Title of Change:	Visual difference on unit surface.
Effective date:	22 Jun 2020
Contact information:	Contact your local ON Semiconductor Sales Office or Esther.Lau@onsemi.com
Type of notification:	This Product Bulletin is for notification purposes only. ON Semiconductor will proceed with implementation of this change upon publication of this Product Bulletin.
Change Category:	Equipment/Tool - General
Change Sub-Category(s):	Addition/Removal/Modification of Equipment Parts, Tooling, Software (Key Feature) that HAS NO impact to product form, fit, function, other than those mentioned in specific processes in this matrix

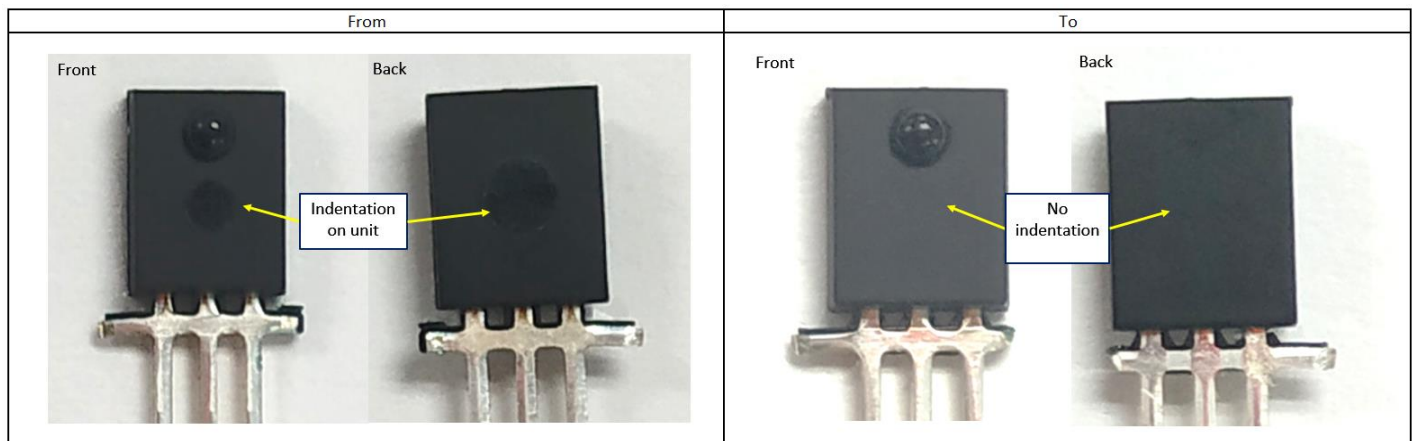
Description of change (From): Indentation on unit.

Description of change (To): No indentation on unit.
